**APPROVED**  
 Limited building only review  
 Permit holder responsible for full compliance with the code

JOB NUMBER	B-1815928
CAD FILE NAME	PRELUDE-L
ISSUED	11-08-17
REVISED	11-16-17
	09-21-18

**PRELUDE**  
**H&H HOMES**

**MAIN FLOOR PLAN**  
SCALE: 1/4" = 1'-0"  
**GARAGE LEFT**

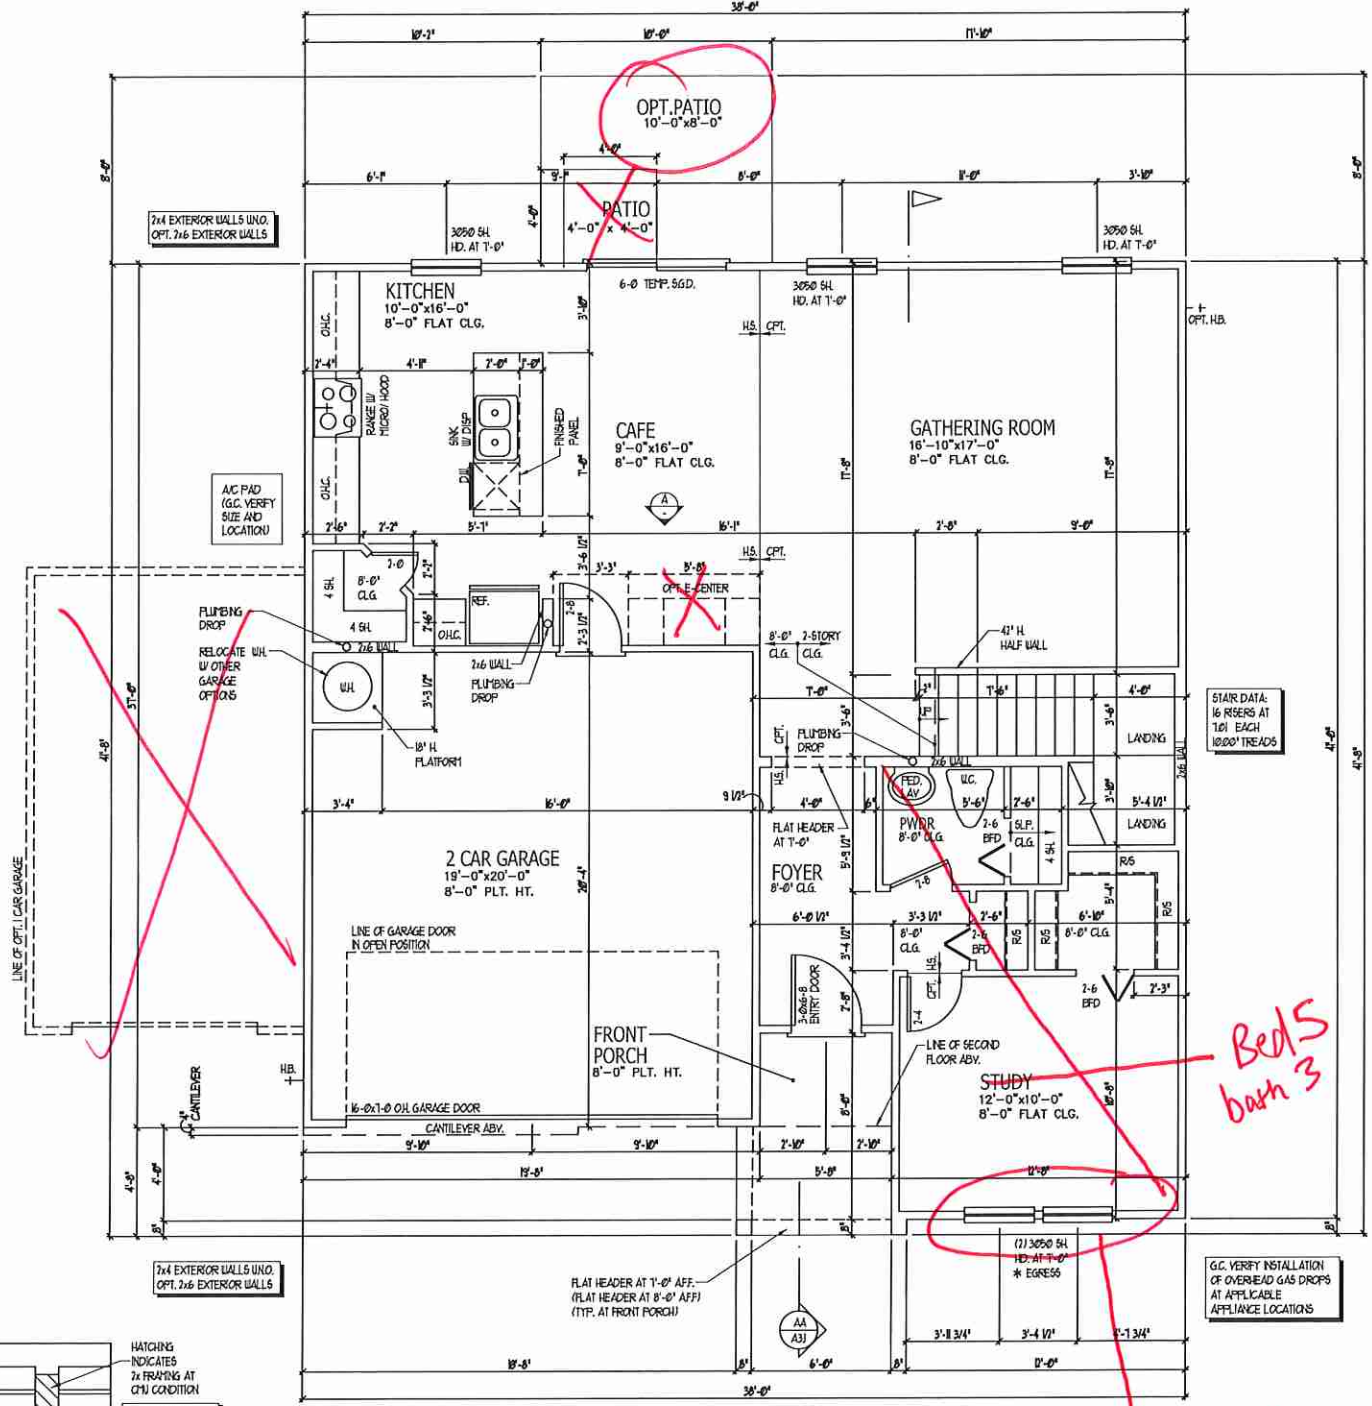
*Beeds bath 3*

*Per elevation C*

UPPER FLOOR PLAN  
 GARAGE LEFT  
 SCALE: 1/4" = 1'-0"

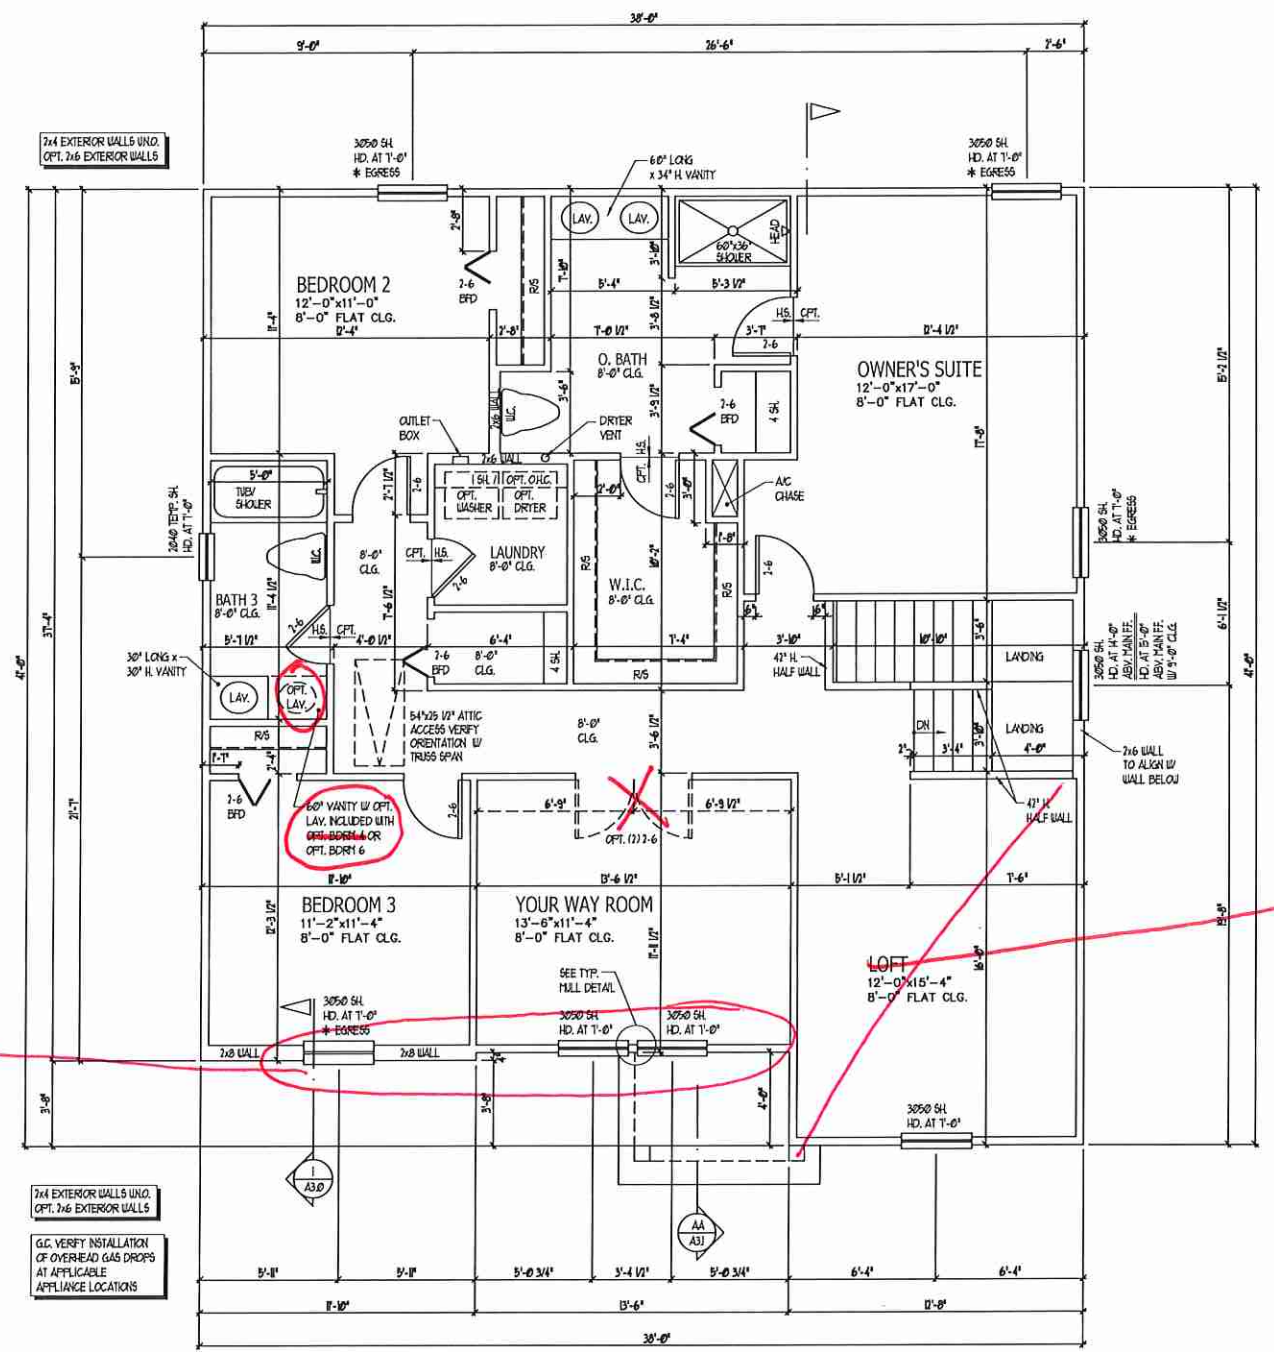
*Per elevation C*

*Bed 6*
